**Meeting Minutes: Central/Buchmiller/Sunnyside Parks
 Master Plans
 Study Committee Meeting #8**

Date: May 21, 2007
Time: 7:00 pm
Location: Shuts Environmental Center - Central Park
By: Chuck Strodoski
Project No.: 06LAN-01

Purpose of the Meeting: To review of the Pre-Final Master Plans for Central and Buchmiller Parks.

Central Park Detail

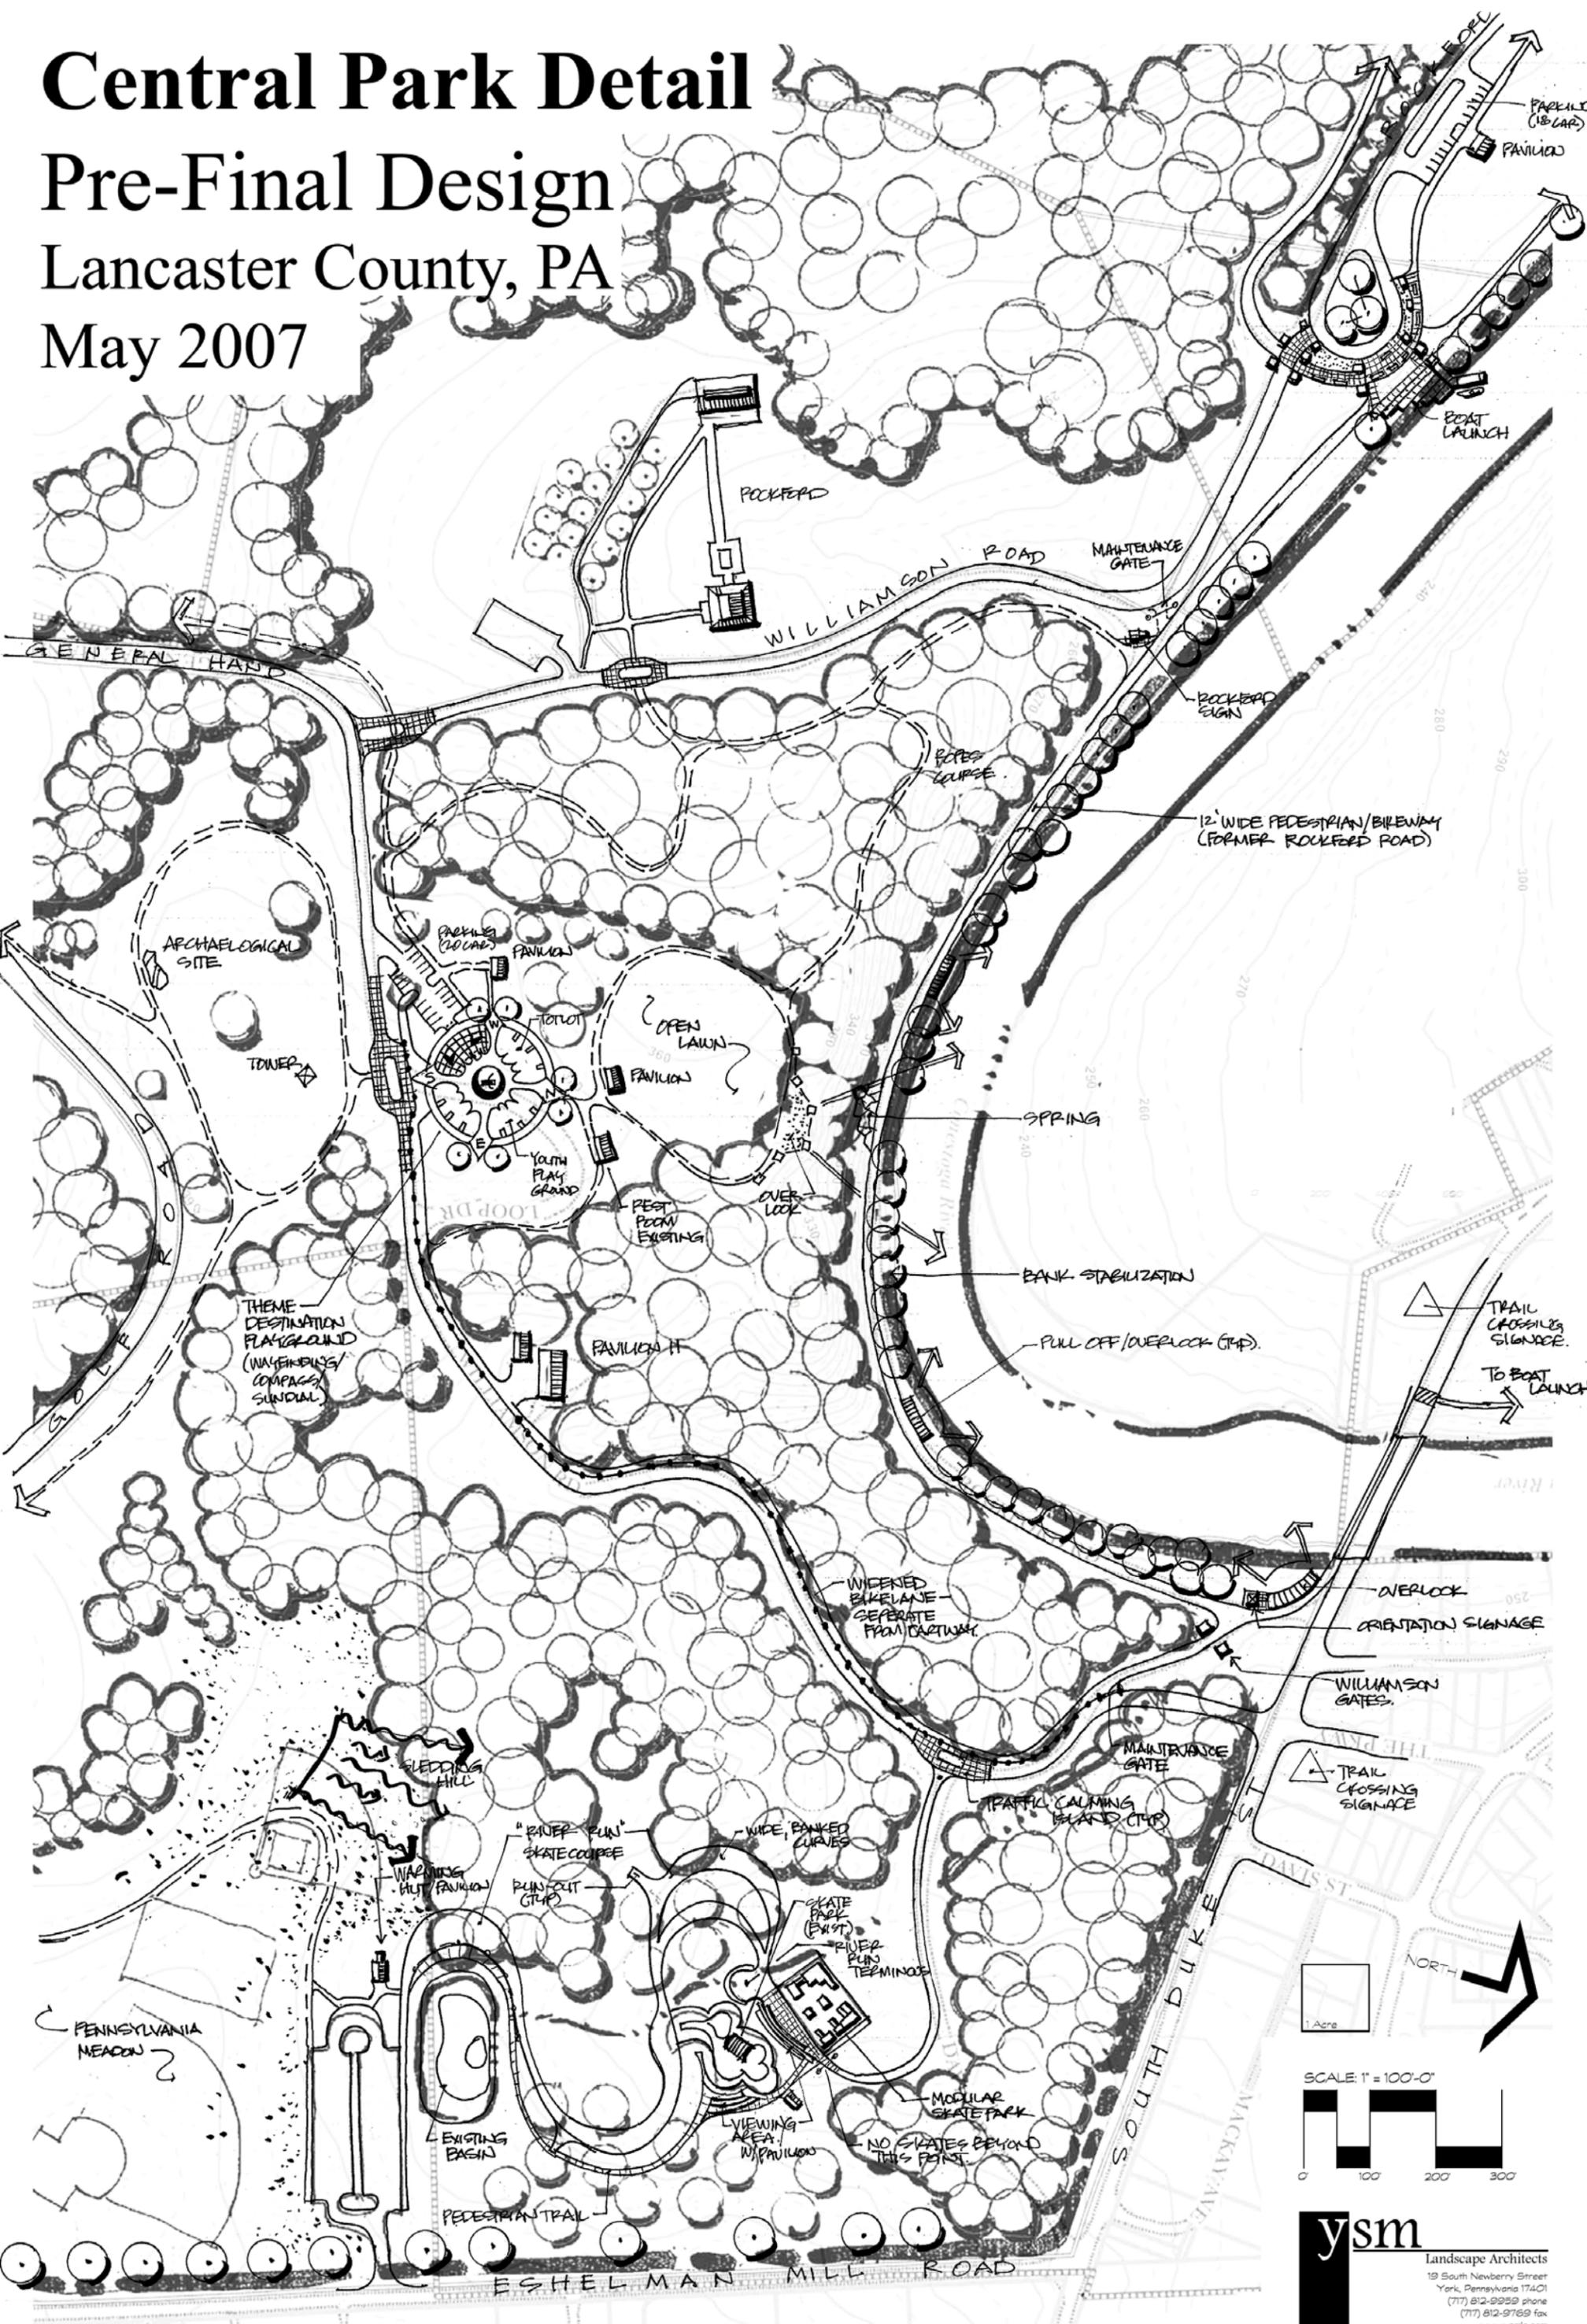
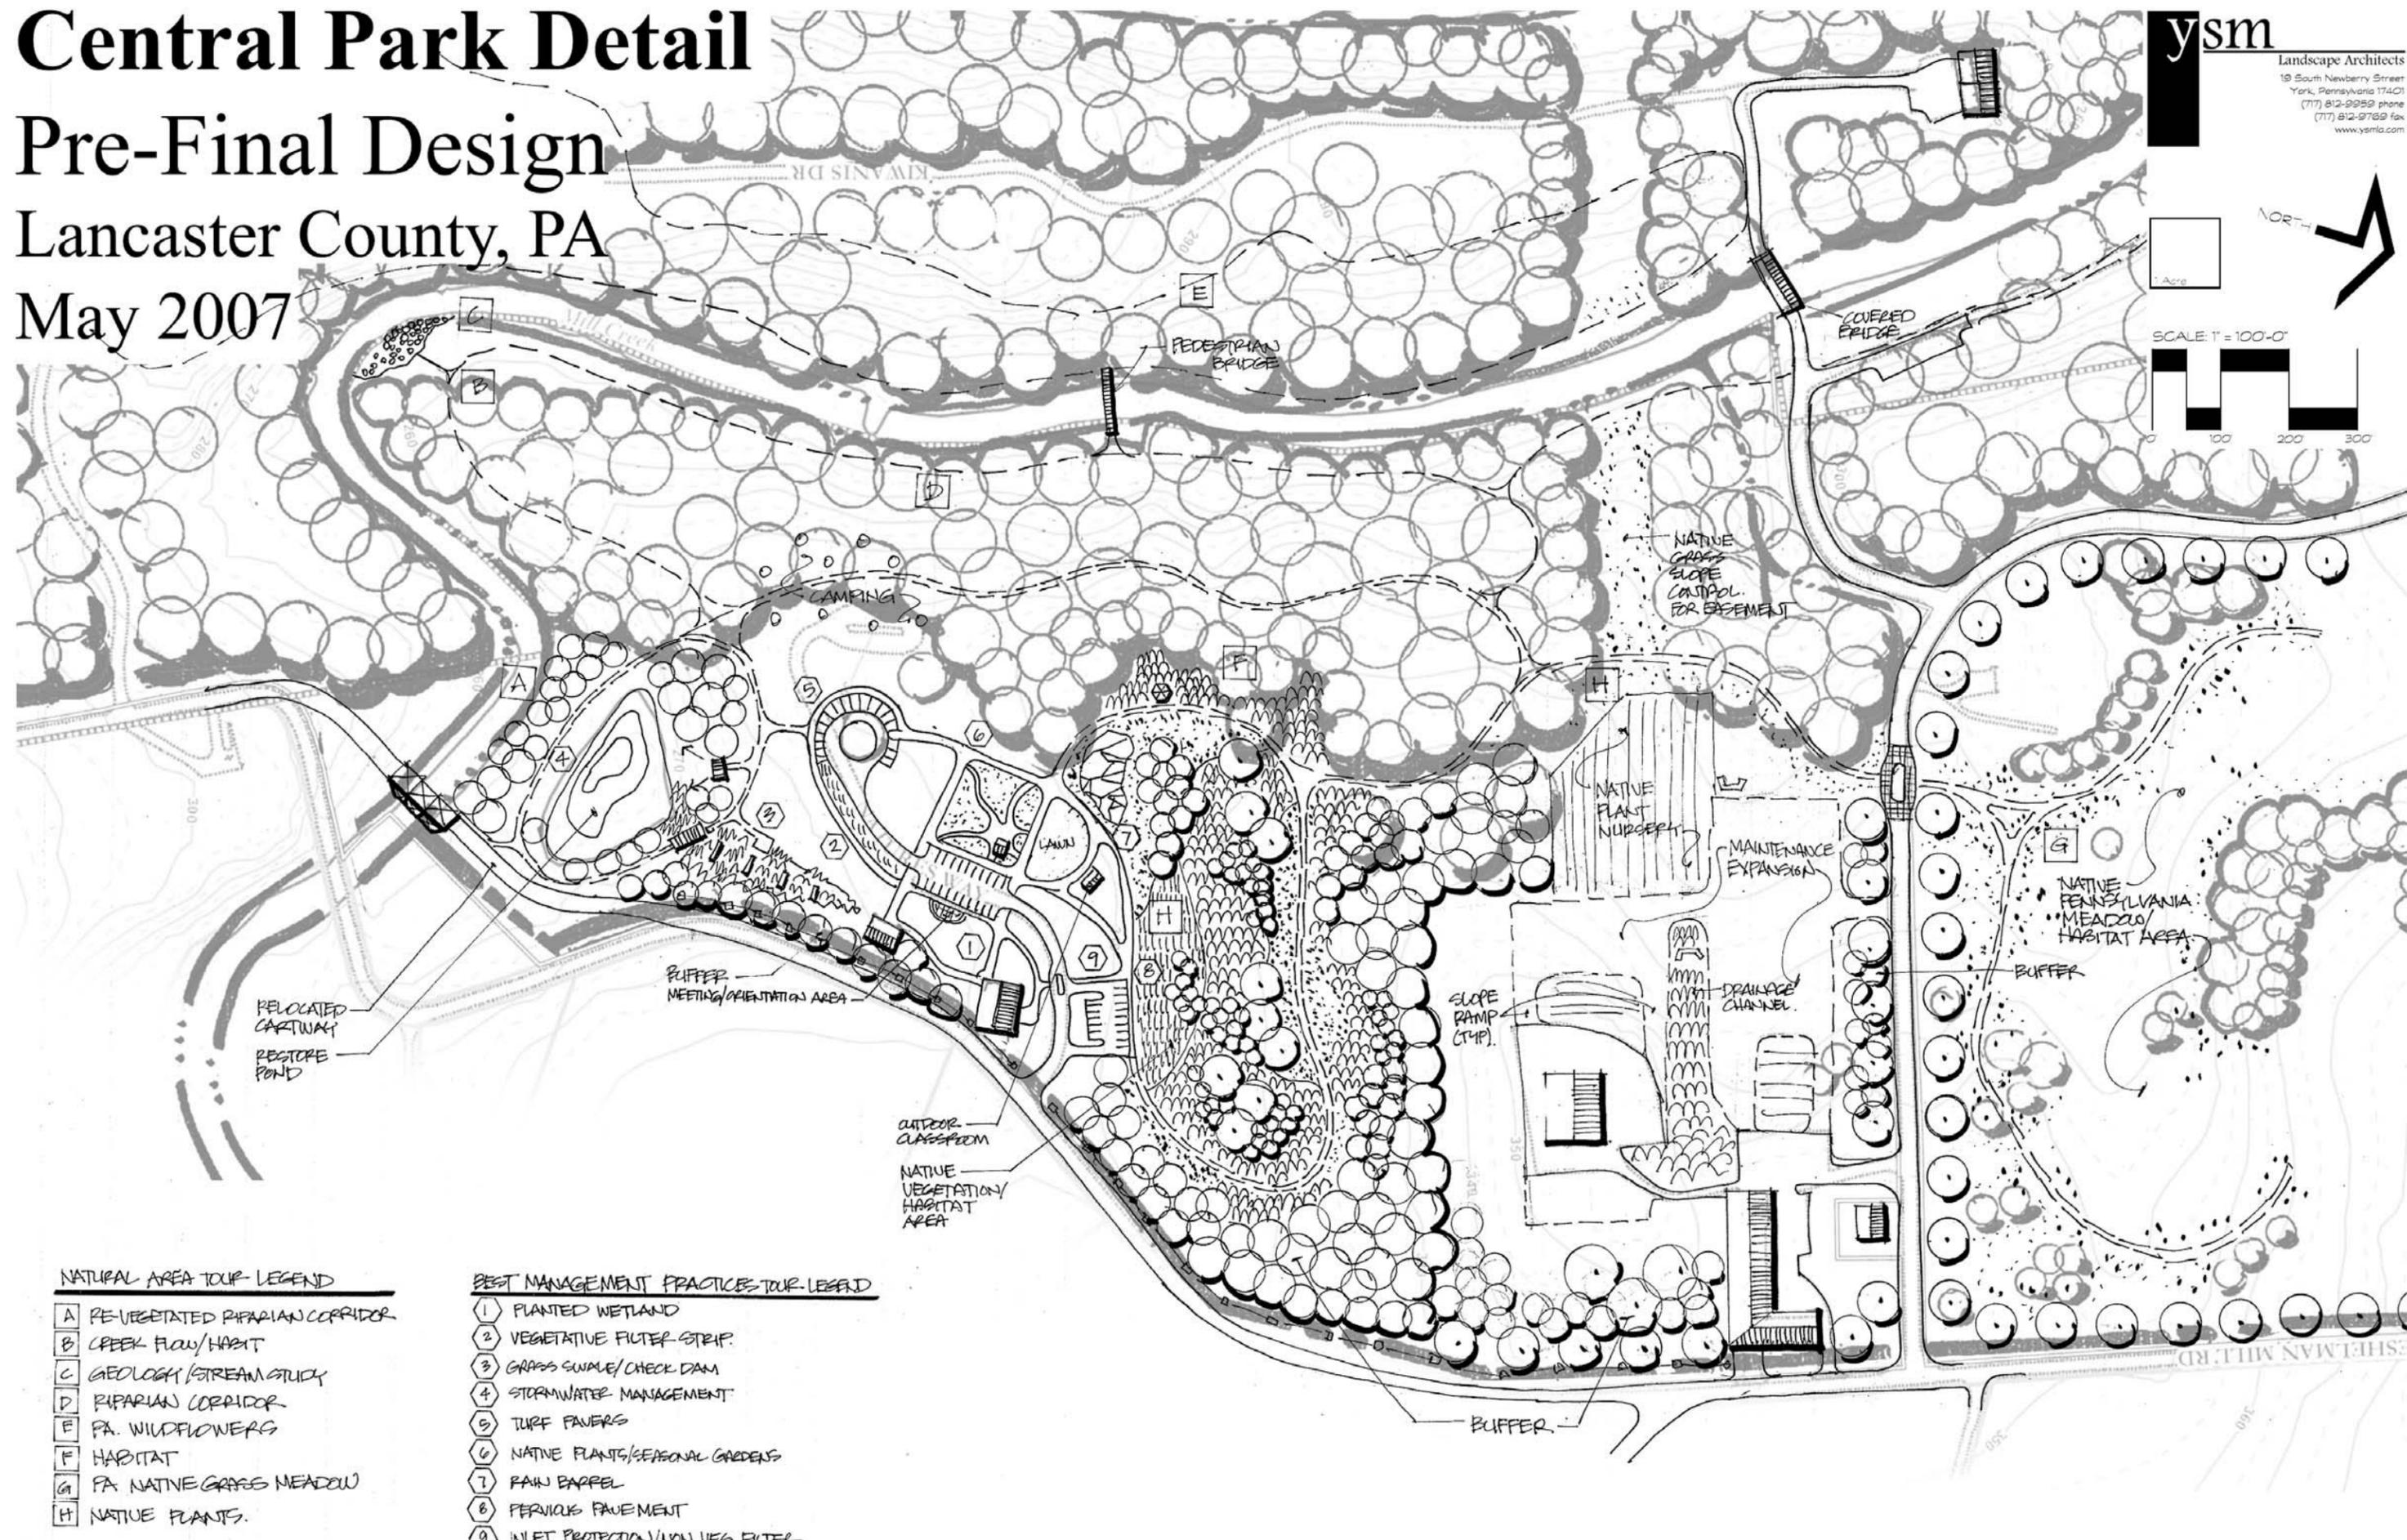
- Generally, the closure of the narrow portion of Rockford Road to vehicular traffic, adjacent to the river was favorably received. Traffic will be encouraged to turn around at the entrance to the Rockford Plantation, through heirachy of streets and entrance elements to direct through traffic away from General Hand Drive. Traffic calming features and narrow cartways will direct general traffic back on to Rockford Road, and create a sense of destination for the Rockford homestead. Through traffic will be permitted but discouraged.
- The proposed parking area associated with the trailhead along the Conestoga River should be corrected to show the correct proposed location.

- Consideration of a loop trail on the north side of the Conestoga River with the closed portion of Rockford Road was suggested. This would create a loop exceeding two miles in length. Easements/agreements/acquisition would be required.

- The anticipated relocation of Eshelman Mill Road should be coordinated with the County Engineer. The realignment and bridge replacement shall be completed in a context sensitive design.

- Numerous ideas on the Pre-final plan will affect traffic patterns in and around the park. These ideas should be communicated to the City/County officials to make them aware of the recommendations and determine the feasibility. YSM will prepare a package of exhibits to submit to the various agencies for review and consideration.

- Pedestrian bridges proposed crossing the Mill Creek are envisioned as pre-fabricated metal, hump back style, to adapt to the flooding potential.
- A proposed trail connection to West Lampeter's trail system should be shown below the existing pond, near the environmental center, on the north side of Mill Creek.

- The number of proposed picnic pavilions was questioned. The plan proposes eight new picnic pavilions. Each pavilion has revenue potential.
- The two picnic pavilions proposed in the open lawn adjacent to the Conestoga River are in the floodplain. Removal of these pavilions was suggested.

- The proposed trails should be developed with a trail marker system.
- Invasive plant species along the banks of the Conestoga River should be addressed. Japanese Hops are dominating the banks. Establishment of a heavy canopy tree cover is recommended by T. Draude to shade out the undesirable species.

- Maintaining the landfill area as a special event area was favorably reviewed. Consideration of a second large event pavilion and additional lawn area at the landfill was suggested to facilitate events.

- The naturalization of the area around the environmental center was favorably reviewed.
- The naturalization of the southern peninsula was favorably received. Naturalization should include a mixture of forest, meadow and grasslands.

- The addition of a small windmill at the pond near the Shuts Library was suggested to drive a well and maintain a flow of water through the pond. In addition to the function, the windmill will add an interesting aesthetic and compliment the existing farmstead structures.
